FORM APPROVED  
OMB NO. 1004-0135  
Expires: July 31, 2010**SUNDRY NOTICES AND REPORTS ON WELLS**  
*Do not use this form for proposals to drill or to re-enter an abandoned well. Use form 3160-3 (APD) for such proposals.*5. Lease Serial No.  
NMNM109756

☒ Oil Well ☐ Gas Well ☐ Other8. Well Name and No.  
PEACHES 19 FEDERAL 3H2. Name of Operator  
OXY USA INCORPORATED

OXY USA Inc. respectfully requests approval for the following changes to the drilling plan:

Utilize a spudder rig to pre-set surface casing for time and cost savings.

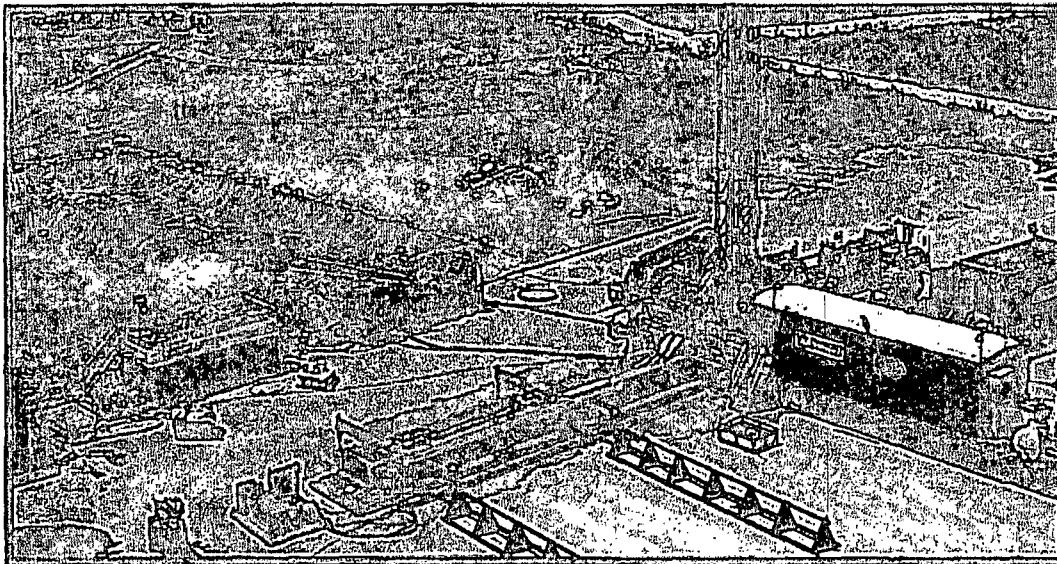
2. The wellhead will be installed and tested as soon as the 10-3/4" surface casing is cut off and the WOC time has been reached.

3. A blind flange as the same pressure rating as the wellhead will be installed to seal the wellbore. Pressure will be monitored with needle valves installed on two wing valves. A means for intervention will be maintained while the drilling rig is not over the well.
